## Migration to New Versions of BM23 Modules

The BM23 modules are being updated with a new Bluetooth SoC. Customers are encouraged to migrate to the newer versions, as older versions will become End of Life (EOL) in November, 2017 and no longer available for purchase. This change is expected to be transparent to end applications. There is no difference in functionality, form factor, pinout, or cost. A new set of software tools used to set Bluetooth and DSP parameters is required to generate the files that are programmed in the device.

**FIGURE 1: DOWNLOADING SOFTWARE PACKAGE**

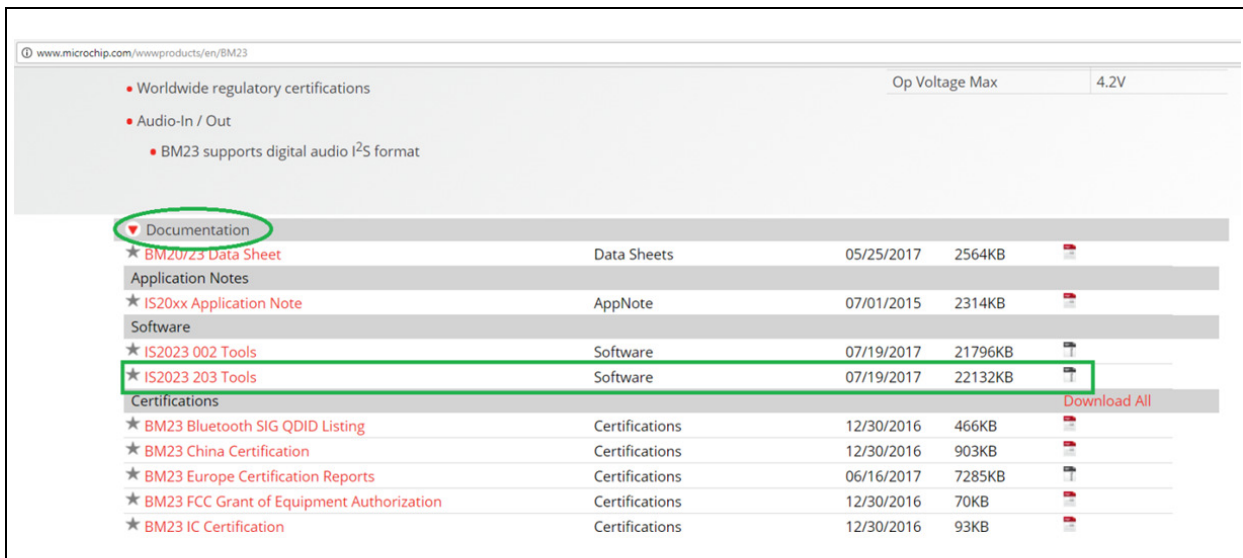
1. Replace the BM23 module with the newer variant. No other changes in hardware is required.
2. Download the “IS2023 203 Tool” software package from [www.microchip.com/bm23](http://www.microchip.com/bm23) as shown in Figure 1.

**FIGURE 2: BM23 EVB**

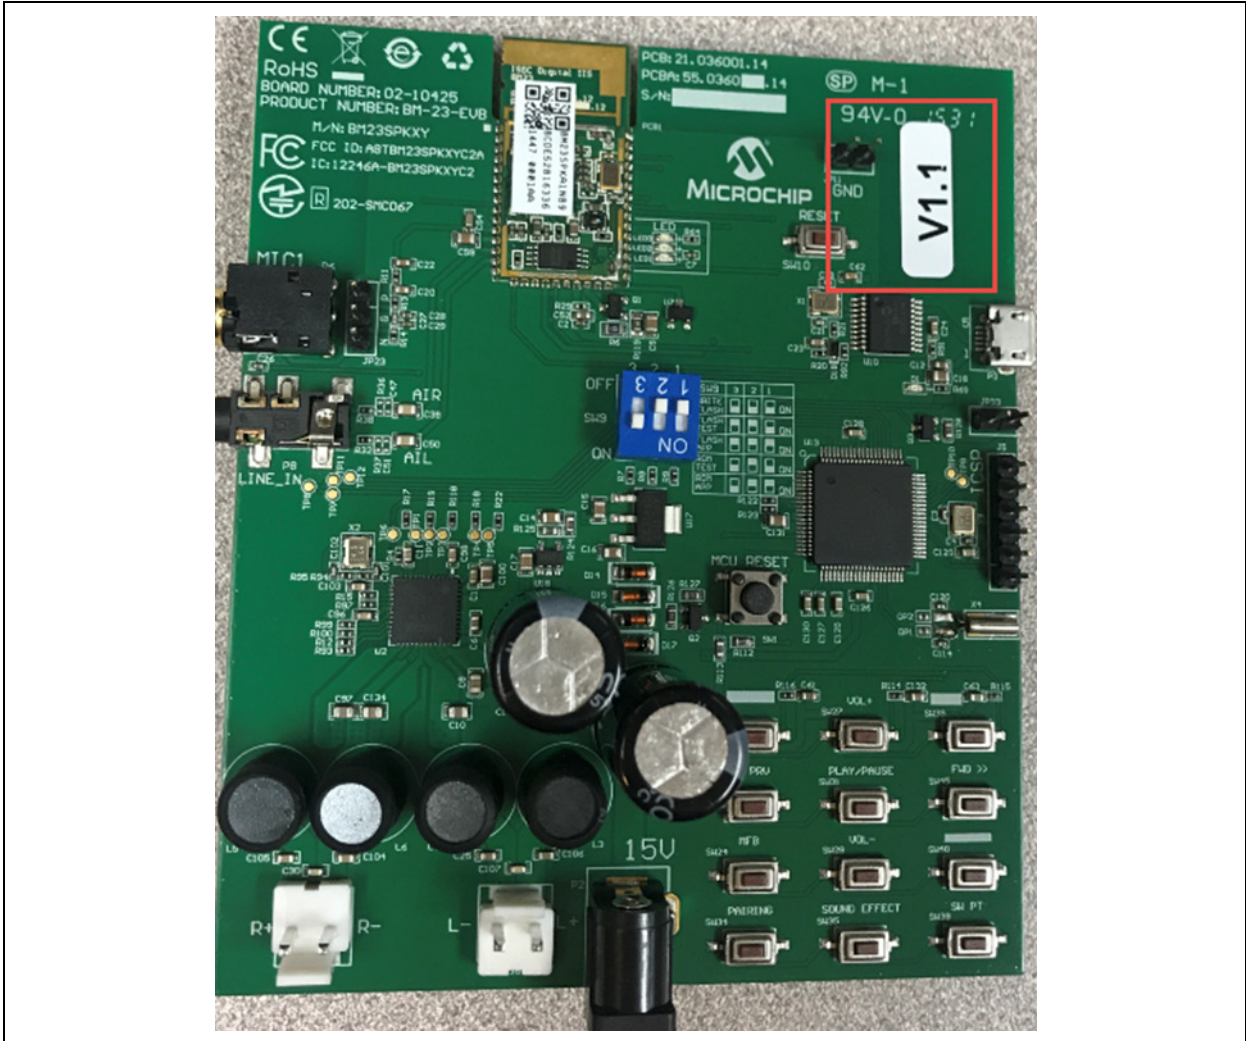
All BM-23-EVB boards with the new version of the module will be marked with a “V1.1” label on the upper right hand corner of the board, as shown in [Figure 2](#).
